Technical Service Bulletin

SUBJECT: CORRECTIONS TO SRS AIR BAG DIAGNOSIS FOR DTC B1631 - SERVICE MANUAL REVISION		No: TSB-19-52B-006	
		DATE: June 2019	
		MODEL: 2011-18 Outlander Sport/RVR	
CIRCULATE TO:	☐ GENERAL MANAGER	☒ PARTS MANAGER	☒ TECHNICIAN
☒ SERVICE ADVISOR	☒ SERVICE MANAGER	☐ WARRANTY PROCESSOR	☐ SALES MANAGER

This TSB updates the Supplemental Restraint System (SRS) section of the affected Service Manuals to correct minor errors in the diagnosis for DTC B1631.

STEP 3. Check SRS-ECU connector C-126 and Knee air bag module connector C-223.

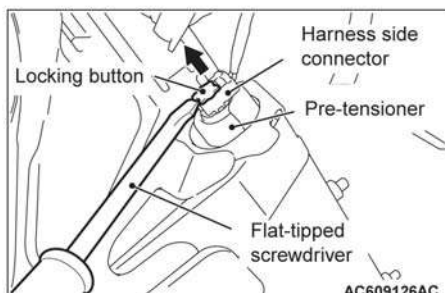
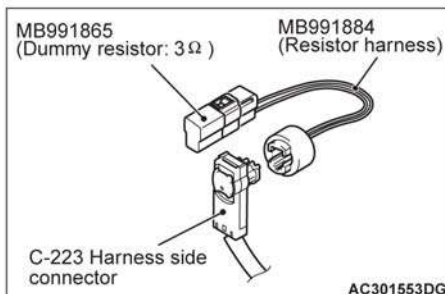
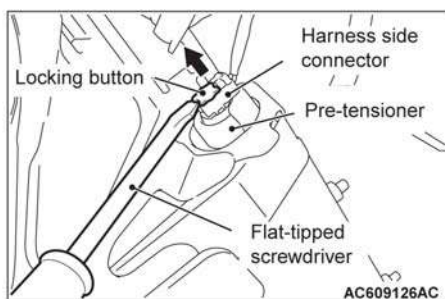
Q: Is DTC ~~B1C36~~ B1631 set?

B1631 <Correct>
